LEAD LOCAL FLOOD AUTHORITY, HERTFORDSHIRE  
COUNTY COUNCIL PROOF OF EVIDENCE IN SUPPORT OF ST  
ALBANDS CITY AND DISTRICT COUNCIL

DEALING WITH MATTERS RELATING TO FLOOD RISK &  
SUSTAINABLE DRAINAGE

BRICKET WOOD SPORTS AND COUNTRY CLUB, PAINTBALL  
SITE & BRICKET LODGE, LYE LANE, BRICKET WOOD,  
HERTFORDSHIRE, AL2 3TF

PINS REFERENCE: APP/B1930/W/24/3338501  
PLANNING REF: 5/2022/2443

Figure 2-3: EA Long Term Flood Risk Map

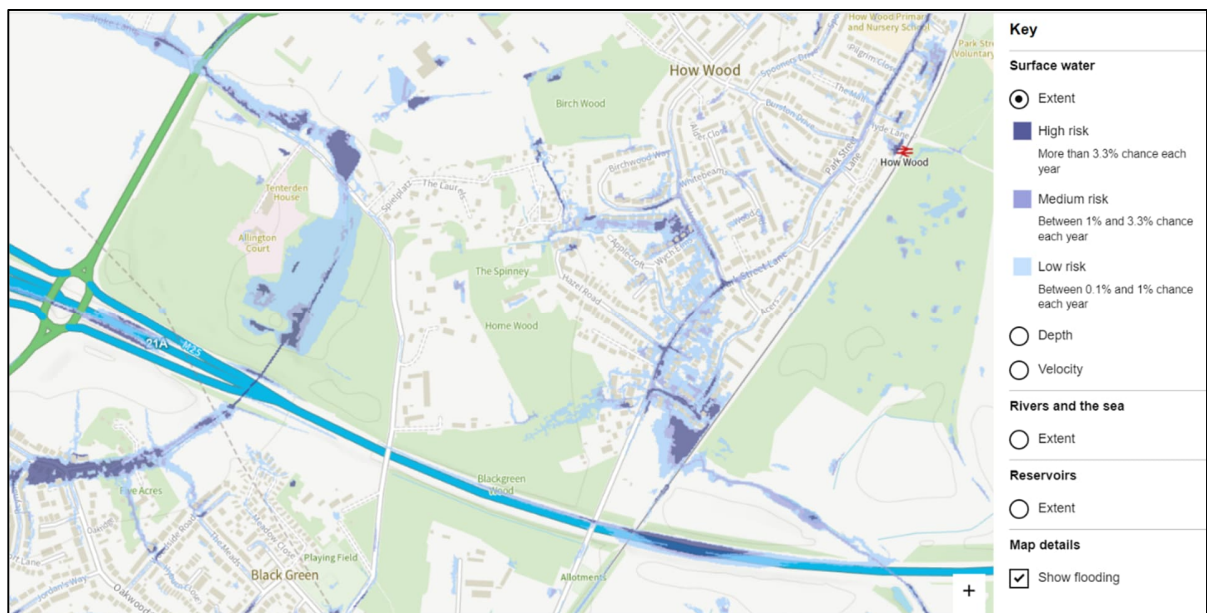
2.1.4 The Flood Risk from surface water map (Figure 2.3) indicates that the site is not at risk of surface water flooding however there is a flow path from the site which contributes to the flood risk of How Wood.

Figure 2-4: extract of watercourse locations from FRA

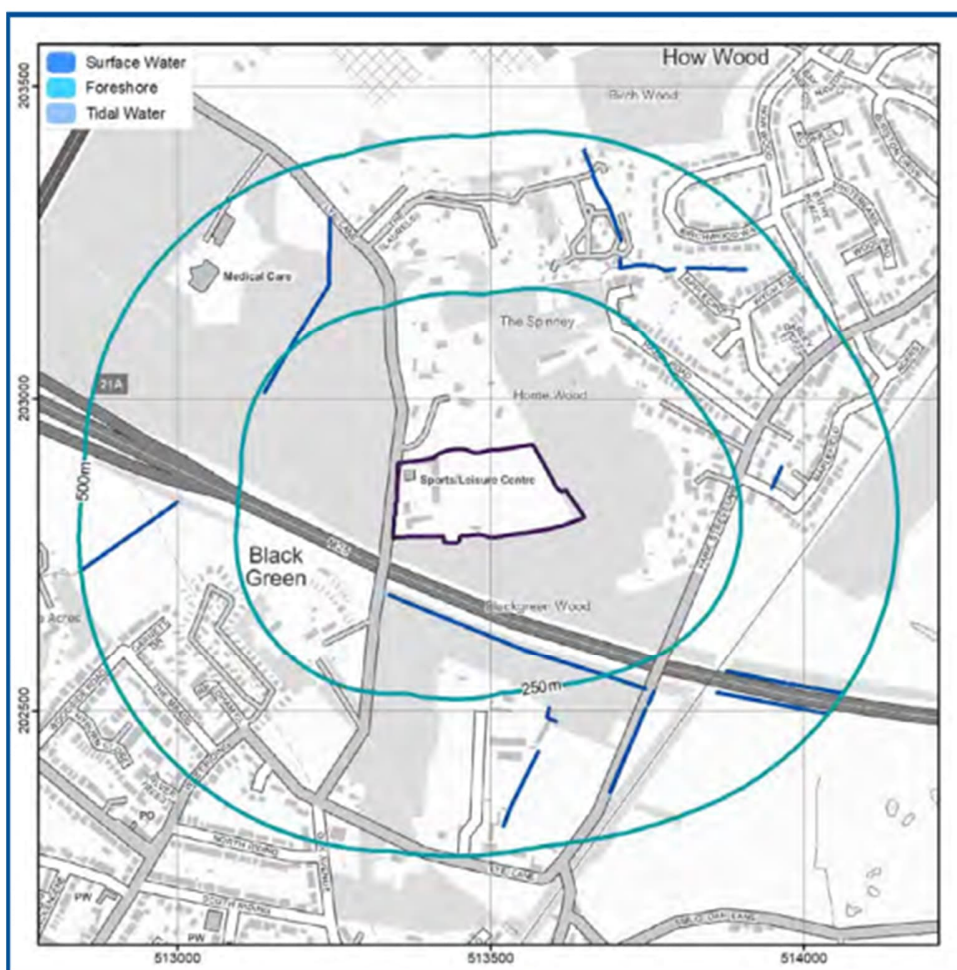
2.1.8 The FRA explains that there are a number of drainage ditches located near the site. These include drainage ditches c. 110 m south, c. 190 m south, c. 240 m north-west, c. 350 m west, and c.360 m north-east of the Site. The M25 motorway (lower than the site and surrounding area) is located between the site and all the ditches to the south and therefore there is no current connection to these from this area. No other watercourses have been identified with the submitted FRA.

- 4.1.10 The Strategy then assess the suitability of discharging to a watercourse based on OS mapping. It states *‘a drainage ditch 260 m north-west of the Site. Given that discharge to ground is unfeasible at the Site and there are no public surface water or combined sewers within the vicinity, it is recommended that discharge to watercourse is considered, and therefore this would be the most appropriate discharge location identified.*

- 4.1.1 The watercourse proposed within the strategy is located uphill to the northwest of the site and it would involve going through third party land, part of which is woodland. The site has no rights to connect to this watercourse and therefore this is not a feasible option.

- 4.1.2 Surface water runoff can not naturally flow to this watercourse. No detail on the impact to the watercourse have been provided, no survey of the watercourse has been undertaken. The increase in volumes and discharge rates has not been considered and therefore the FRA and drainage strategy fail to demonstrate the site would not increase flood risk to others. Any increase in Volumes and rates will increase flood risk downstream of this watercourse which already impacts the residential area of Bricket Wood.
